VRU-Proxi-06-04

Informal document **GRSG-114-XX**  
(114<sup>th</sup> GRSG, 09-13 April 2018  
agenda item 5)

## **Proposal for a new Regulation on uniform provisions concerning the approval of motor vehicles with regard to the Blind Spot Information System**

The text reproduced below was prepared by the secretary of the IWG on Awareness of Vulnerable Road Users proximity in low speed manoeuvres (VRU-Proxi) to demonstrate the current status of the proposed regulation on Blind Spot Information Systems.

Figure 1: Dynamic Tests

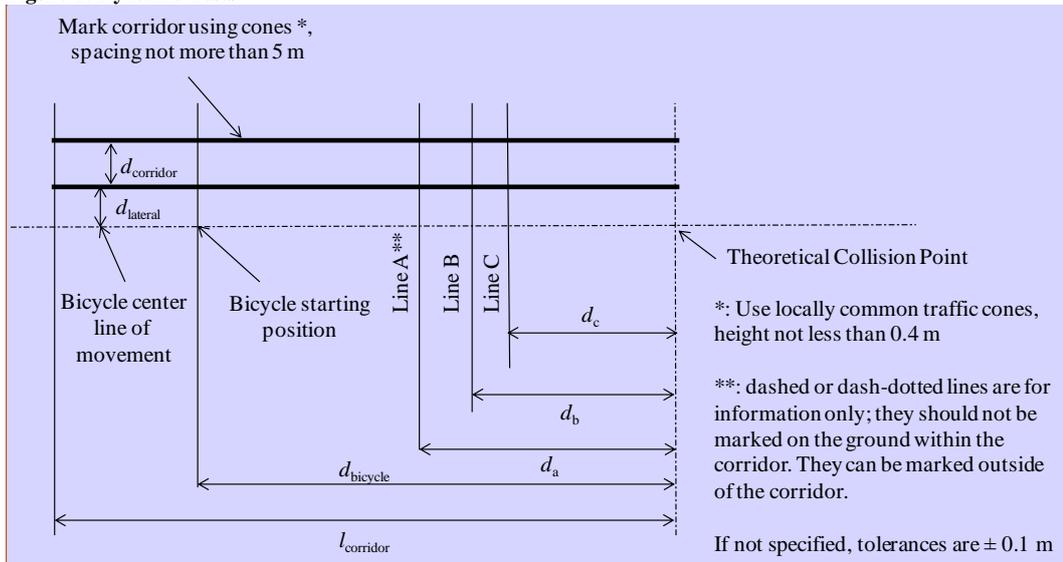
**Opmerking [SP30]:** OICA recommends to keep the corridor on vehicle width  $\pm 0.5$  m as a narrower corridor only makes the test more difficult for the driver with added value. Reducing the corridor and is also less representative for the reality.

**Opmerking [s31]:** Line D (similar to lines A,B,C) will be included after decision for FPI at next IWG meeting.

Figure 2: Static Tests

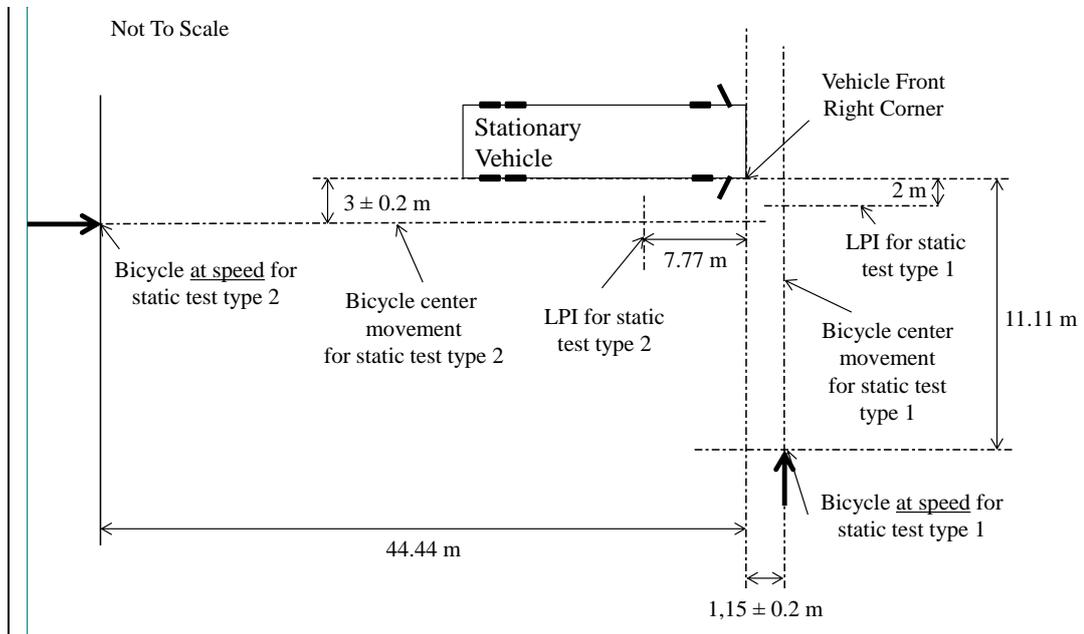
**Opmerking [w32]:** Correct errors, make clearer
